**City of Phoenix**  
PLANNING & DEVELOPMENT DEPARTMENT

**BUILDING CONSTRUCTION CODE CHANGE PROPOSAL**

**Proposed Amendment to 2018 International Energy Conservation Code (IECC)  
Section C302.1**

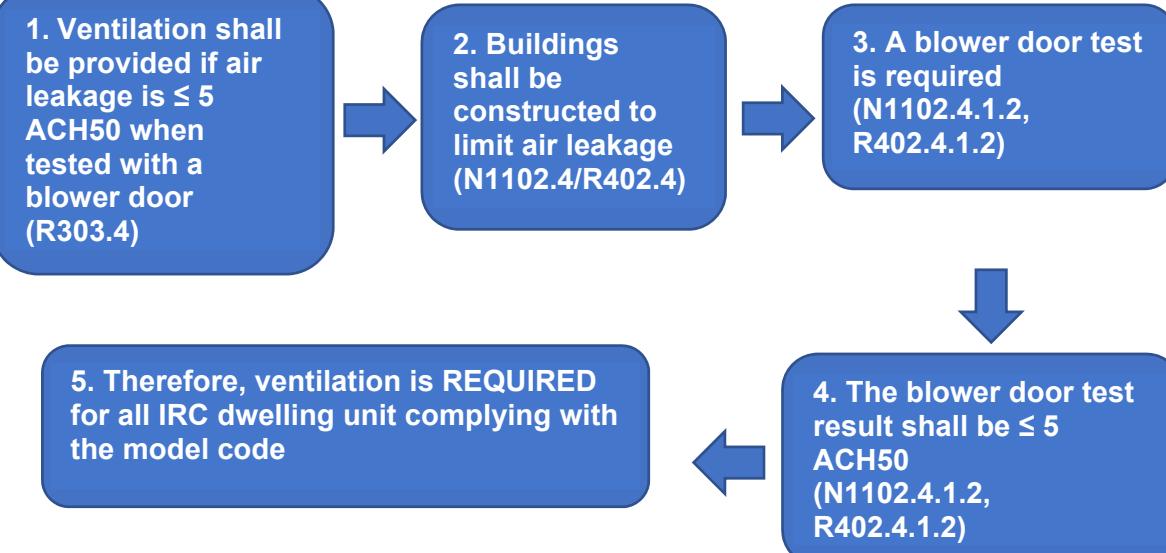
So, since 2012, the code has required tight dwelling units to also be provided with mechanical ventilation. The problem is that we've heard from ICC staff, code officials, builders, and design professionals that it's hard to follow the code language requirements. Currently, we have a 5-step process to identify that mechanical ventilation is required for all IRC dwelling units; this introduces needless confusion. Here's what the process looks like:

Instead of a 5-step process, we can simplify the code and enforcement by jumping straight to the conclusion: ventilation is required for all dwelling units. This proposal does exactly that. Additionally, this proposal introduces an exception for the mechanical ventilation requirement in climates and situations where natural ventilation is expected to provide all of the climate control and ventilation needed (i.e., when no space-heating or cooling equipment is provided). A similar exception exists in ASHRAE 62.2.

**Reason Denied by Subcommittee:**

This amendment would require mechanical ventilation be installed in all IRC dwelling units that have additions and remodel permits as well as new home construction, regardless of the air infiltration rate of the structure. This is not the intent of the code, nor is it feasible. The base code requires dwellings that have an “air-infiltration rate of 5 air changes per hour or less, where tested with a blower door at a pressure of 0.2 inch w.c.” to be provided with mechanical ventilation. The base code references section N1102.4.1.2 which describes the testing medium and specifications. N1102.4 in the code section title paragraph that limits the air leakage through the building thermal envelope in accordance with N1102.4.1 through N1102.4.5. These sections define sealing various building components (fireplace dampers, fenestrations, recessed lighting, etc.) and the aforementioned testing criteria.

The mechanical ventilation requirement was introduced as thermal envelope sealing in new construction became tighter, developing “sick building” syndrome, where air inside new dwellings became stale and unhealthy. Current code language limits mechanical ventilation to newly constructed dwellings by setting the air-infiltration rate threshold. Removing this language expands the requirements to any residential IRC designed structure under permit.
